Engineering Note			
Title:	RBX-PCB-EX02-C1 to C2 Extruder PCB mod sheet		
Project:	CEL Robox	No.	RBX-PCB-EX02-C1
Engineer:	Pete Tarver	Date:	09/11/2021
Pages:	2

During testing of the rev C1 assembly the following changes have been found necessary for a more robust, noise filtering, solution:

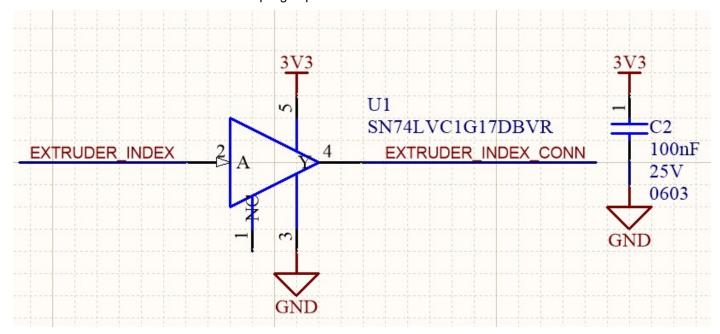
1. Add resistor: directly solder to R1 pin 1, and wire link the other end to J3 pin 9:
